May 20, 2019

RE: Comments of Natural Resources Defense Council, Friends of the Earth, and Miami Waterkeeper on the Draft Supplemental Environmental Impact Statement for Turkey Point Nuclear Generating Units Nos. 3 and 4 (NUREG–1437, Supplement 5, Second Renewal, draft) (Docket ID NRC-2018-0101).

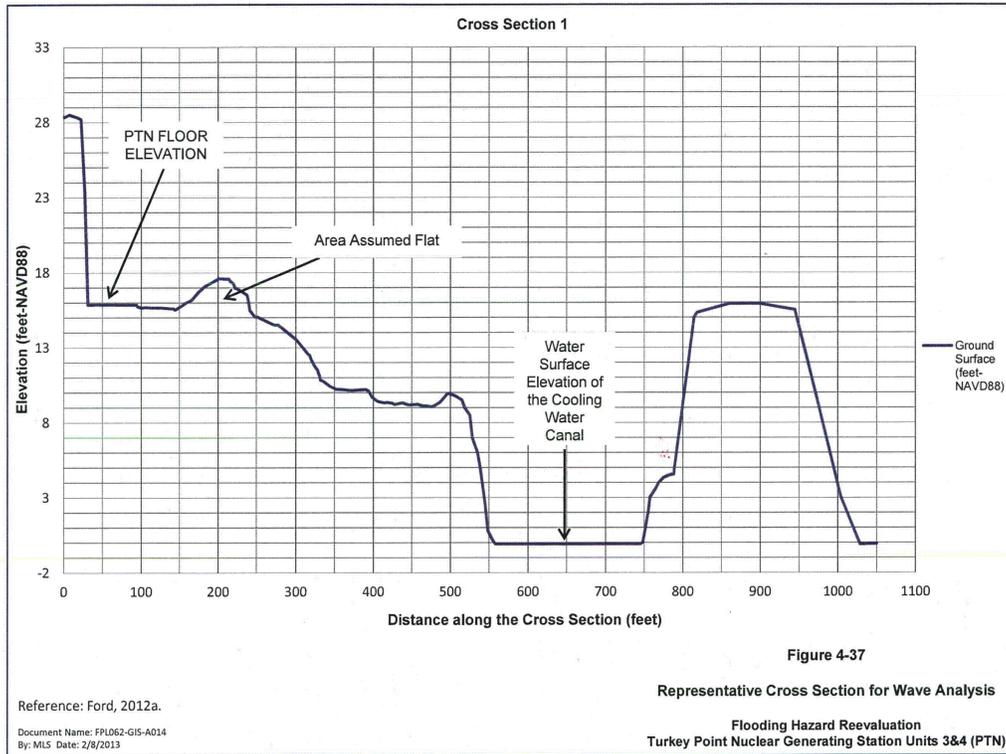
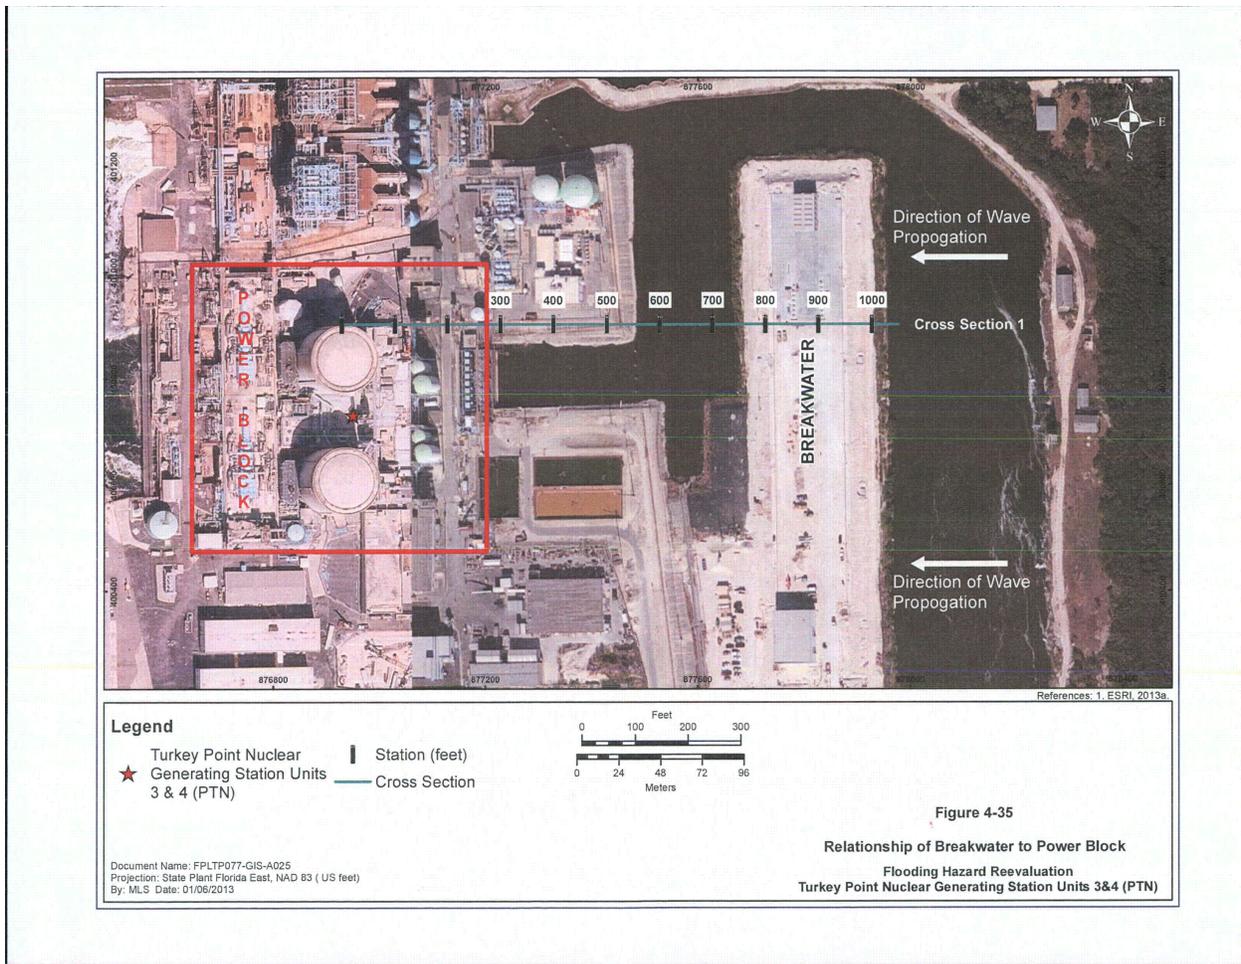
FPL’s own studies demonstrate surface water discharges from the cooling canal system are foreseeable. Figure 4-37 below is a representative cross section of the Turkey Point plant.²⁹ Below that (Figure 4-35) is a bird’s-eye view of the cross section. FPL’s consultant prepared these figures in connection with an NRC-mandated “Flooding Hazard Reevaluation Report” following the Fukushima disaster. The studies show, and NRC Staff confirm, that flood water levels could reach up to 19.1 ft NAVD88³⁰—well above the 16 ft NAVD88 height of the breakwater barrier east of the power block shown in Figure 4-37 that separates Biscayne Bay from the cooling canal.³¹ Notably, this modeling effort only accounted for sea level rise through

the current license period.³² It did not account for additional projected sea level rise and other climate-related flood risks during the subsequent license renewal period.

While the NRC Staff evaluated flooding for safety purposes, it ignored the impacts of flooding on the environment. The impacts of overtopping the cooling canal system are significant. Pollutants in the cooling canals will inundate the Biscayne Bay and the surrounding environment with hyper saline water, tritium, sediment, ammonia, and other pollutants in the cooling canals.
